CULEBRA MARKET SHOPPING CENTER  
PRELIMINARY OVERALL AREA DEVELOPMENT PLAN  
POADP NO. \_\_\_\_\_

Re: Culebra Market Shopping Center POADP # 656

## P.O.A.D.P REVIEW

# REQUEST FOR REVIEW of POADP

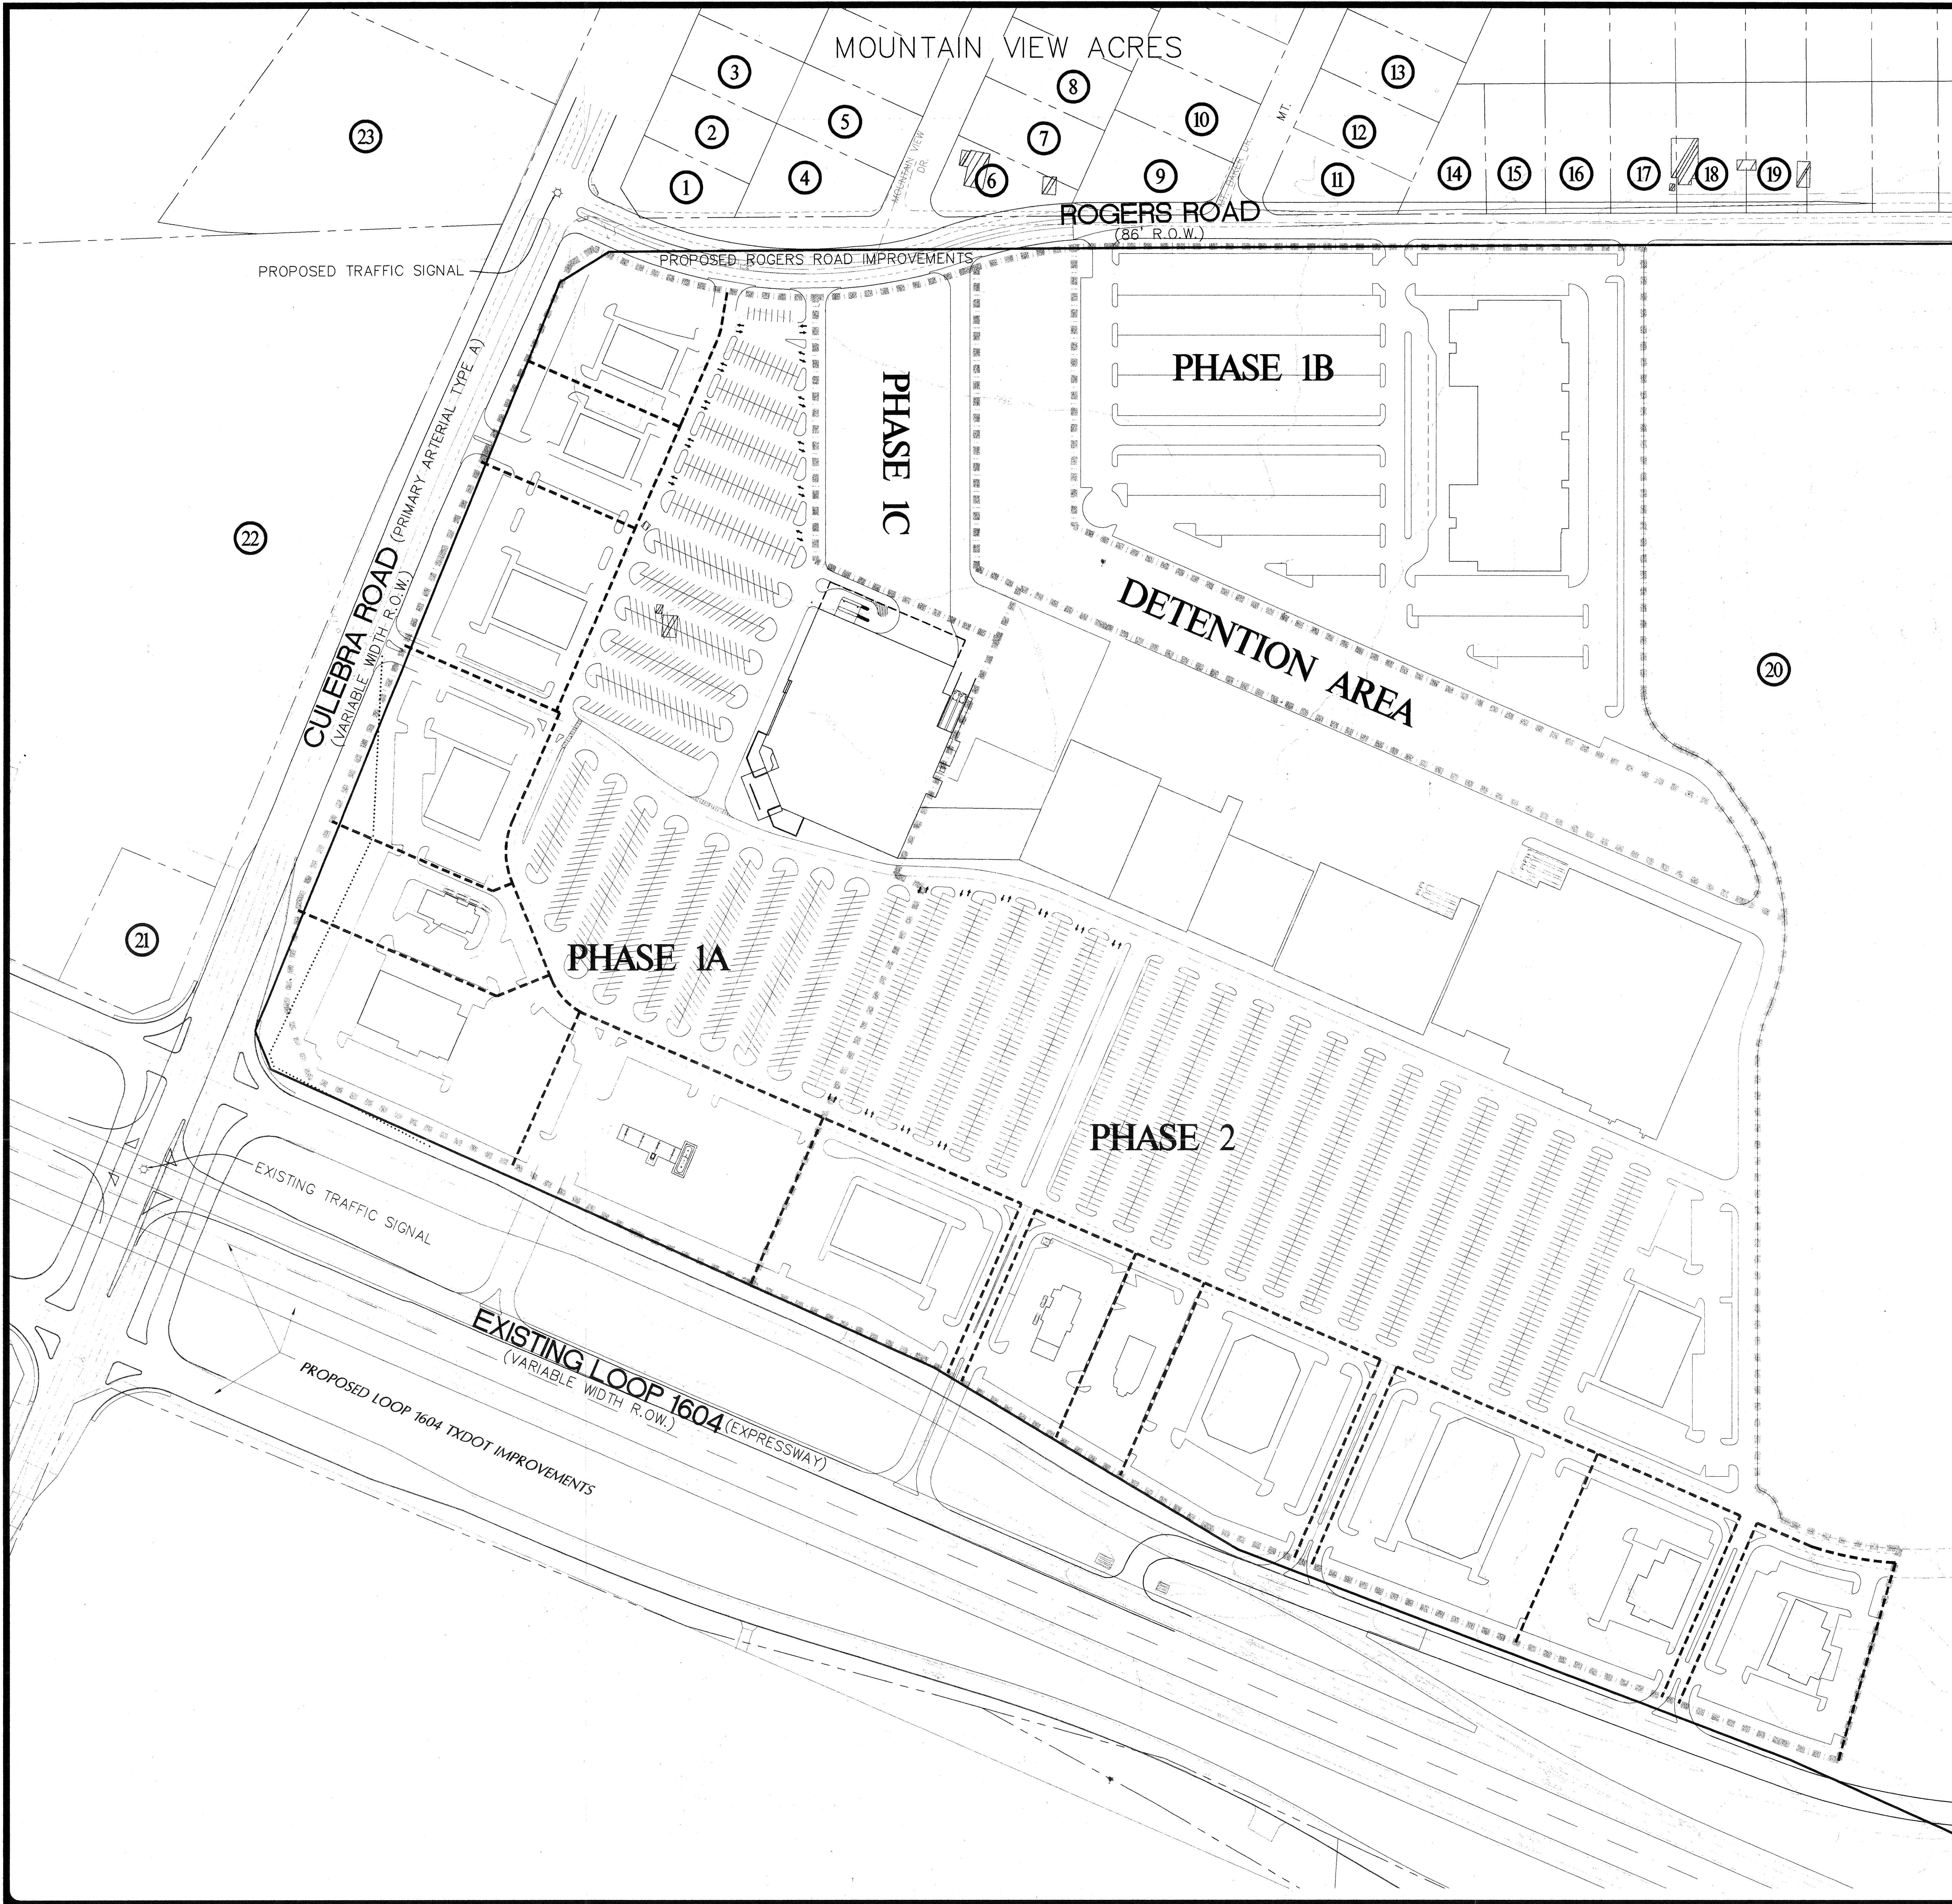
- Based on the topography, a Flood Plain Study and drainage review will probably be required during the platting process
- In consideration of public safety and convenience, excessive grades by reason of topography should be avoided in street layouts and arrangements.
- Access and R.O.W. issues along State facilities will need to be resolved with the Texas Department of Transportation (TXDOT). For information about these requirements you can contact TXDOT at 615-5814.
- This development will need to comply with tree preservation ordinance #85262. For information about these requirements you can contact Building Inspections at 207-7102.
- It will be expected that you will plat all of the property depicted in your POADP, to include: floodpains, drainage areas and open space.

For residential development directly adjacent to State ROW, the developer shall be responsible for adequate set-back and/or sound abatement.

Future expansion plans for this corridor, requires additional right of way at the intersection of Loop 1604 and FM 471. At the time of platting, TxDOT will require a dedication of this proposed right of way as depicted on the Loop 1604 right of way maps.

This development is eligible for a maximum combined total of four (4) access points along the overall Loop 1604 frontage and two (2) access points along the entire FM 471 frontage. Locations will be as directed by "Regulations For Access Driveways to State Highways".

Comments: Will need fire Access to the North of Phase 2 Bldgs  
OK W.J. Burns 12/20/99

Comments: Loop 1604 is a Mayor thoroughfare class, filed as a  
expressway requiring a min. of 300' R.O.W. FM 471 (Culebra Road)  
is a primary arterial-Type A requiring 110' R.O.W. Plat need to show  
R.O.W. and dedication. Plat need to show R.O.W. and dedication. Refer  
to dot for highway system notes.

- ROW widths need to be shown on all streets (Rogers Rd, 1604 and Culebra Rd.) Dedication may be required at time of platting on any of these streets.
- Building inspections has indicated a fire access to the north of Ph. 2 buildings is needed. Contact William Burris, Fire Protection Engineer, (x-8248) for more info. He has approved the plan, however, this requirement may be imposed at the time of platting.
- A review has not been received from the City Arborist concerning landscaping or tree preservation.
